**RE: Town of Kittery, Planning Board Services
523 US Route 1, Aroma Joe's Site Plan Review Application
Tax Map 66, Lot 26; Mixed Use (MU) Zone
CMA #591.139**

Re: Kittery Aroma Joes | Site Plan Peer Review Comments

Haley Ward, Inc. (Haley Ward) has prepared the following response to the review comments on the 523 US Route 1 Aroma Joes development, provided by Jodie Strickland (CMA Engineers) on April 19, 2022. The comments have been provided in bold italics, followed by our response.

TYPICAL SEWER TRENCH DETAIL
N.T.S.

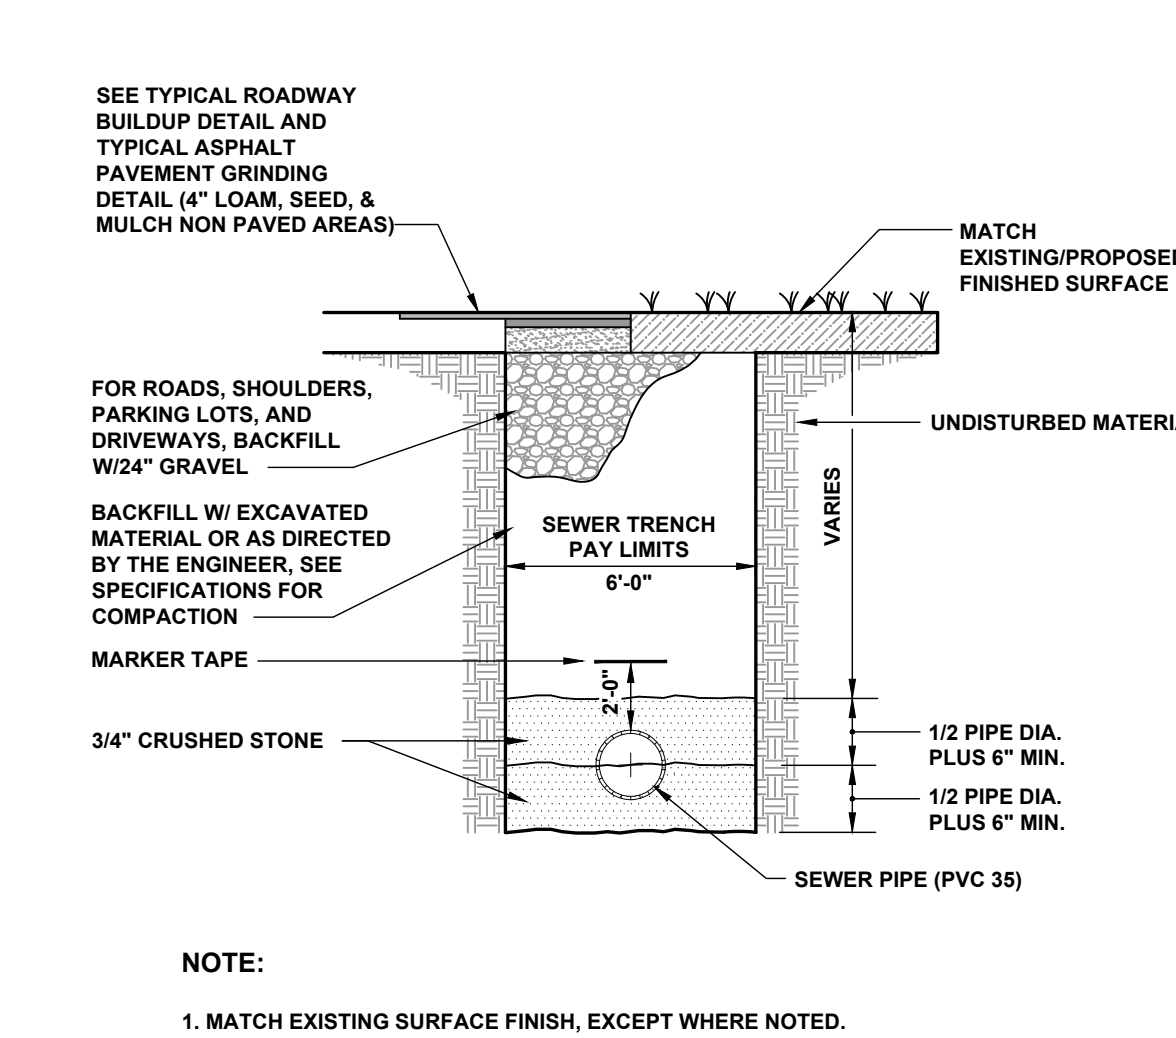
The applicant should indicate the size and material of the service.

The plans should provide details for the sewer service (size, material, bedding, etc.)

- 5. The applicant should indicate the size and material of the sewer service.**

- 6. The plans should provide details for the sewer service (size, material, bedding, etc.)**

A detail of the proposed service has been provided on the Detail Sheet.

A detail of the proposed service has been provided on the Detail Sheet.
